FEDERAL COMMUNICATIONS COMMISSION

In re: K232EM, Seven Oaks, OR
BMPFT-20131028ACG
Facility ID # 156664

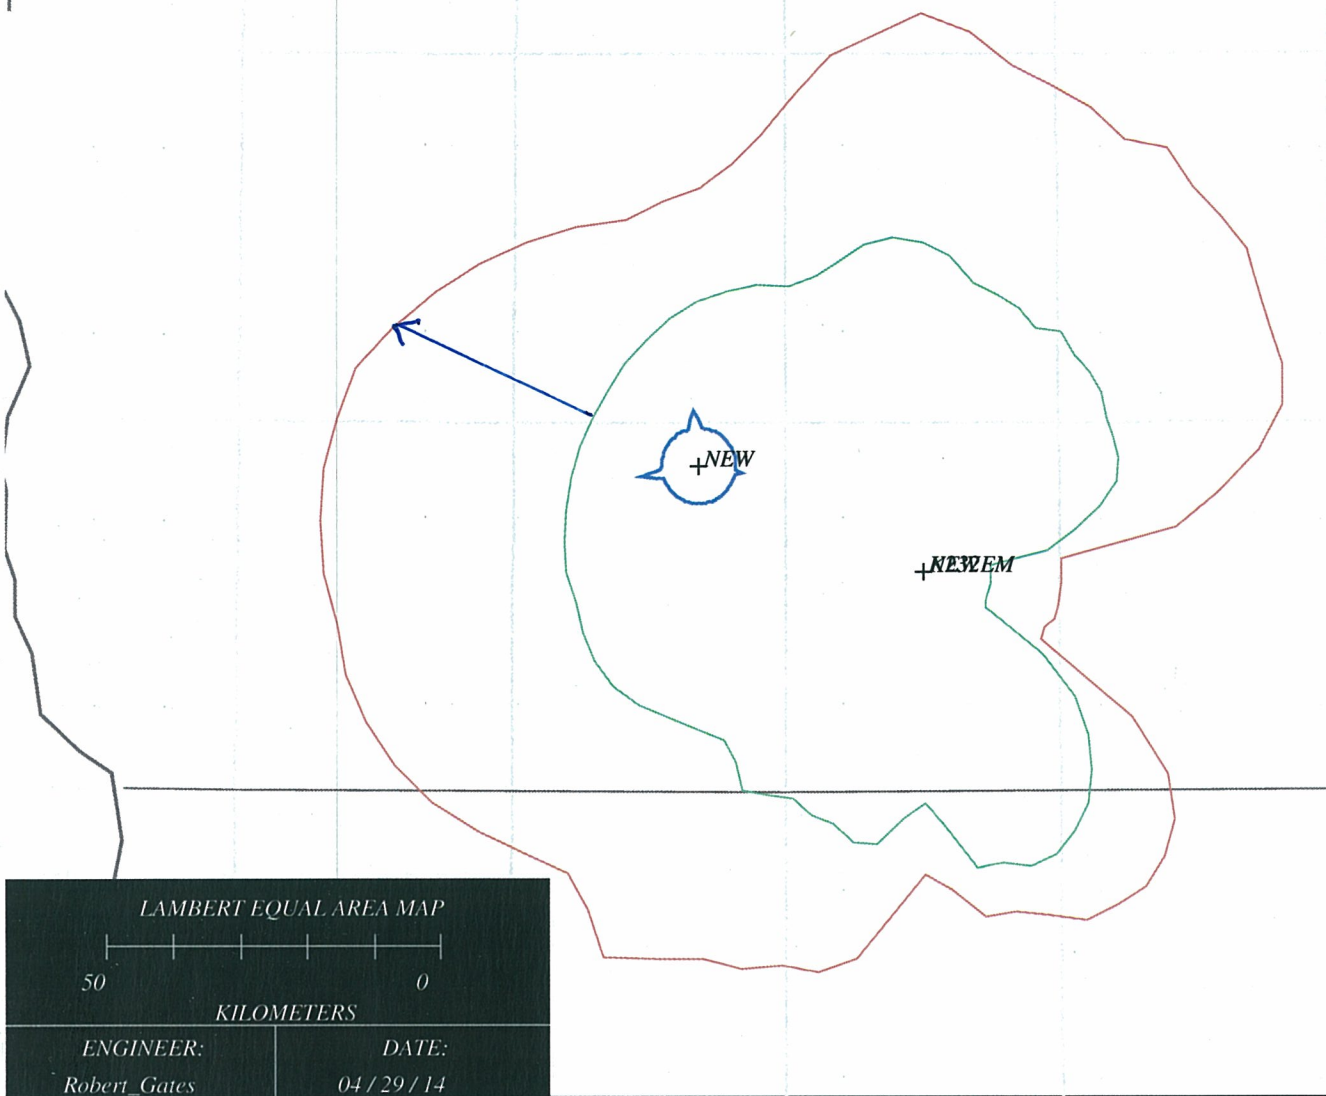
An engineering study has revealed the application violates 47 C.F.R. § 74.1204(a) with respect to KRRC-LP, Rogue River, Oregon (BNPL-20131108AHI). Section 74.1204(a) states that an application for a FM translator station will not be accepted if the proposed operation would involve prohibited overlap of predicted field strength contours with any other authorized station. The proposed 40 dBu interference contour increases the overlap with the 60 dBu protected contour of KRRC-LP. This violation was not addressed.

In light of the above, the application BMPFT-20131028ACG filed by Community Media Assistance Project is unacceptable for filing pursuant to 47 C.F.R. § 73.3566(a) and IS HEREBY DISMISSED. This action is taken pursuant to 47 C.F.R. § 0.283.
